## SUBMITTAL TRANSMITTAL

**Submittal #: 16231-001.A**

PROJECT: **Harold Thompson Regional WRF**  
Birdsall Rd.  
Fountain, CO 80817  
Job No. 2908

SUBJECT: Resubmittal - Response to April 9<sup>th</sup> Review of the Packaged Engine  
Generators: 600 kW & 1250 kW GenSets w/ 800 Amp & 2000 Amp ATS's

TITLE: ELECTRICAL STUB UP  
 SIZE B DWG NO: P2011-0139A REV: B  
 SCALE: 1:40 DO NOT SCALE SHEET: 3 OF 3

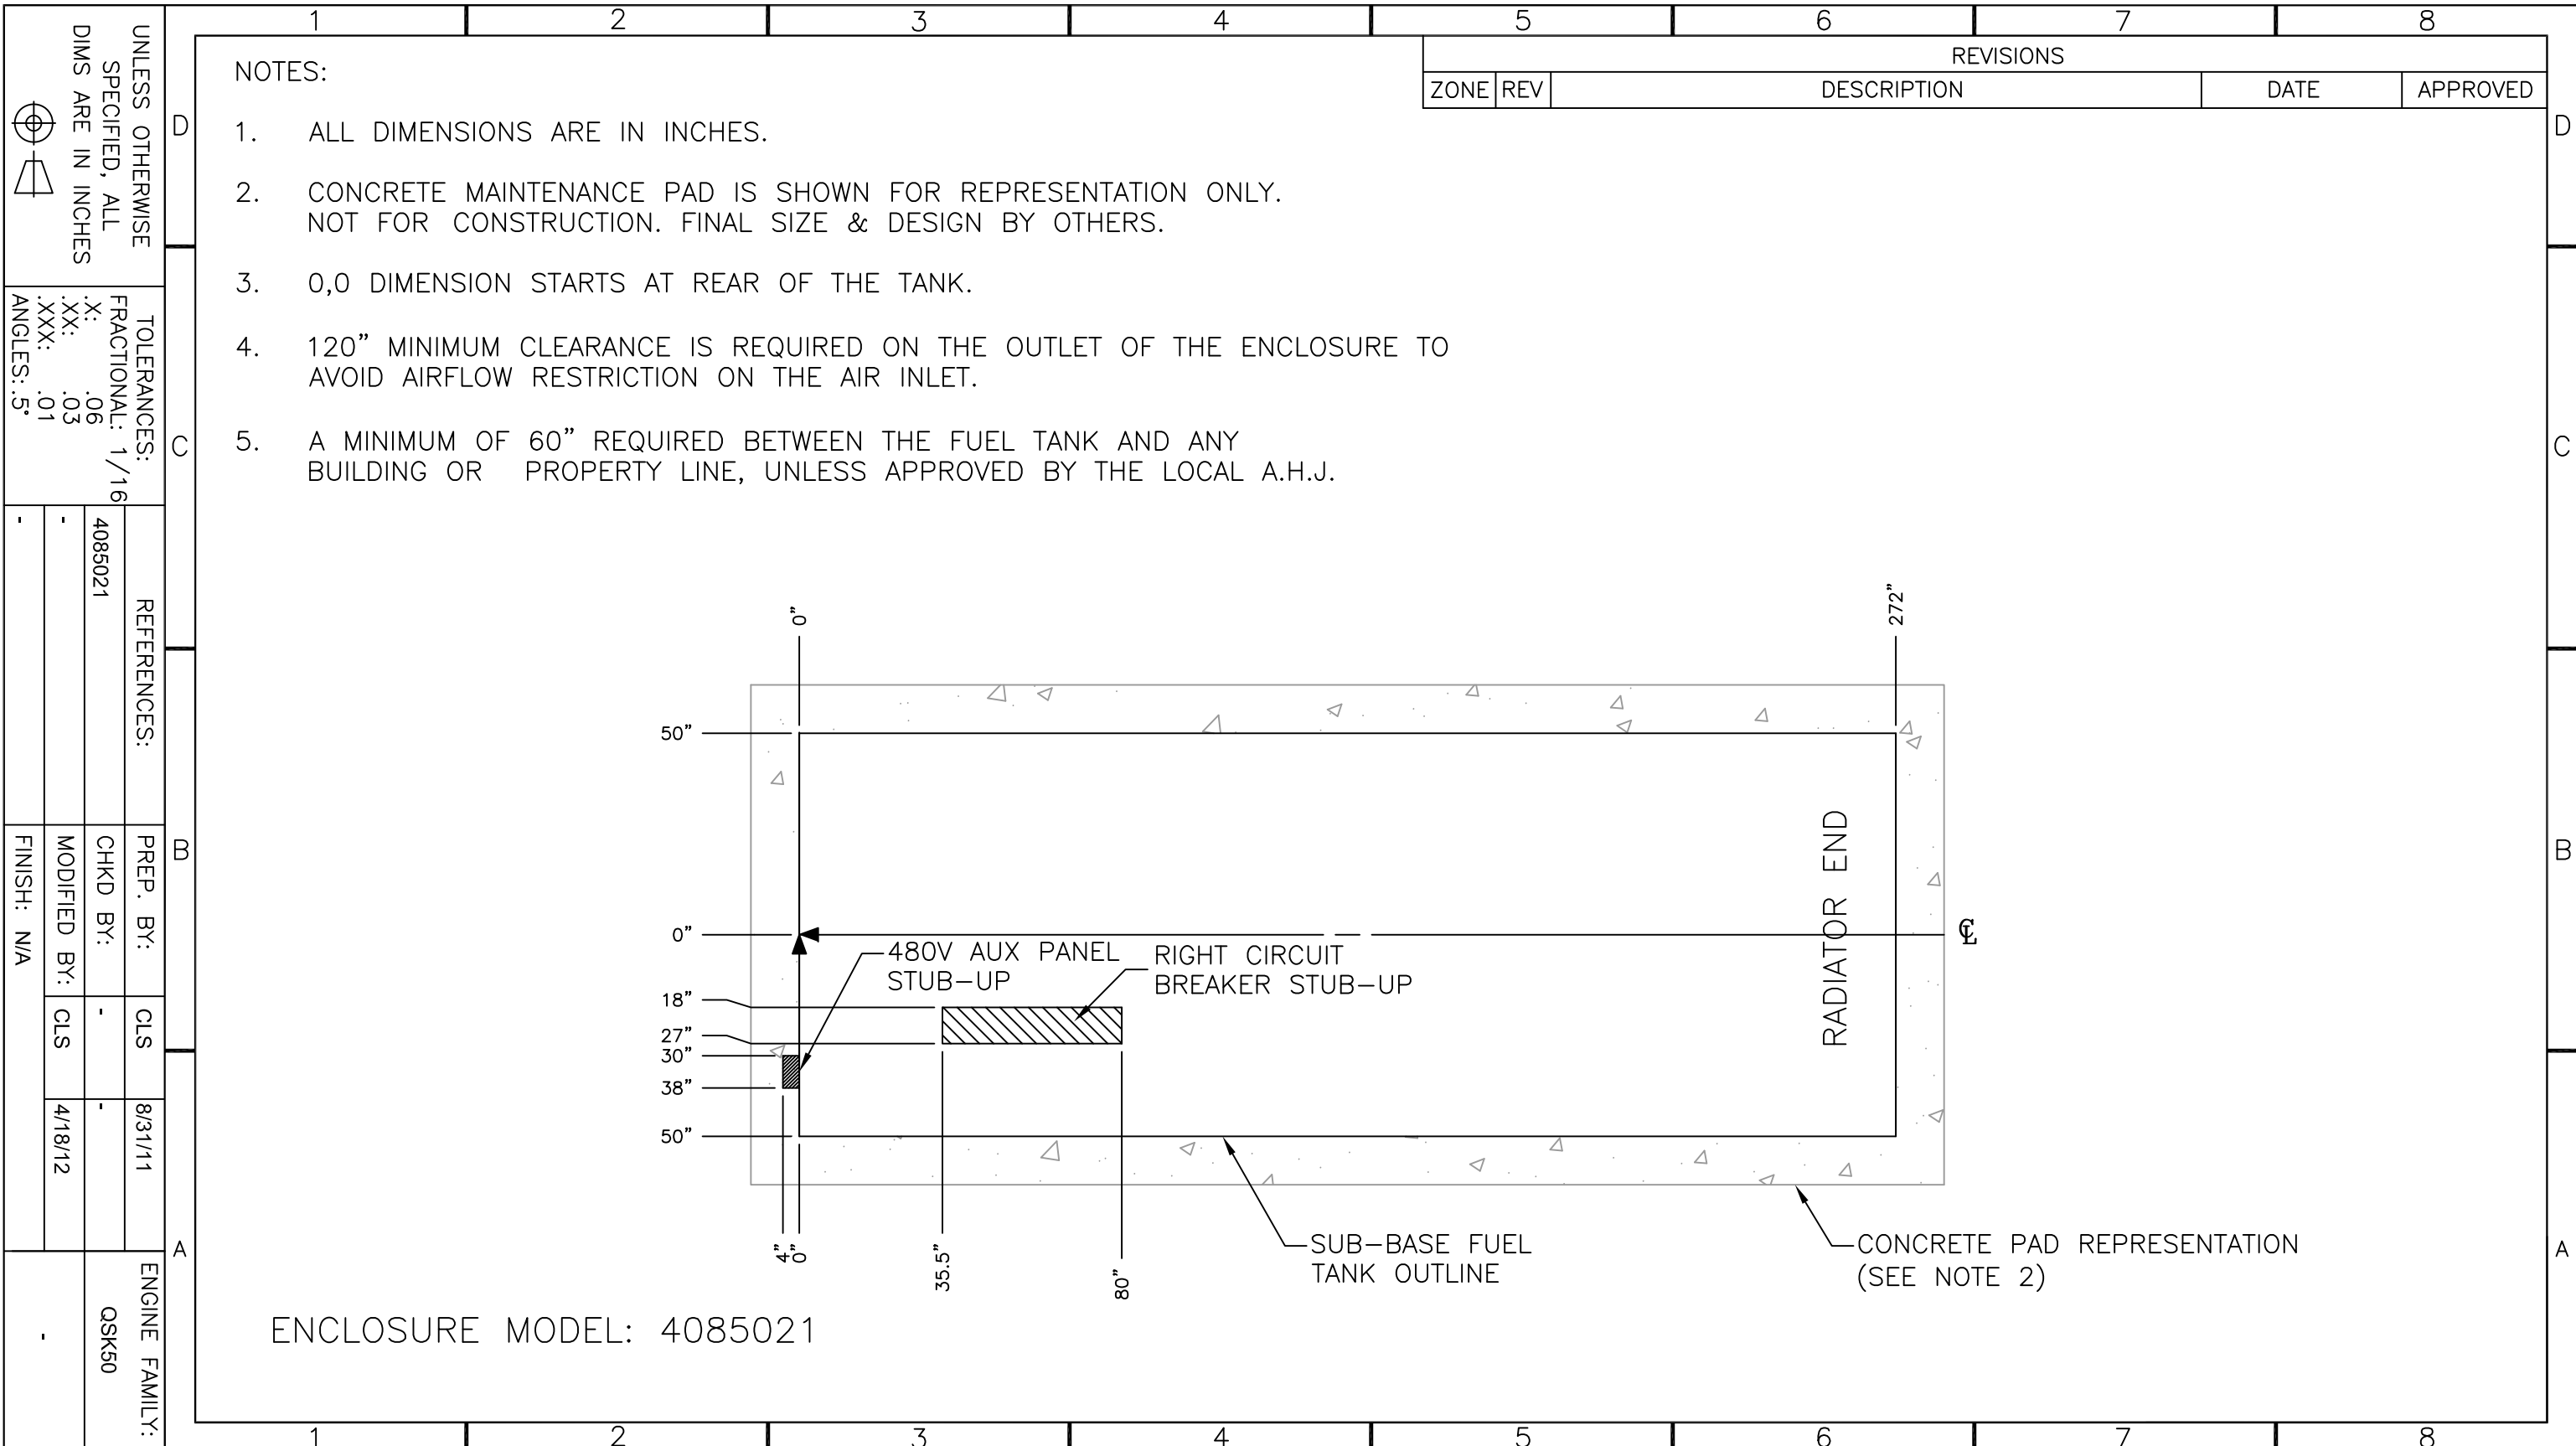
- c.) Generator Layout: Drawings indicate generator main breaker to be located left side of generator (west side). Change main breaker location to right side (east side, facing EM building).

*Cummins Response: The circuit breaker will be located on the right side of the control.*
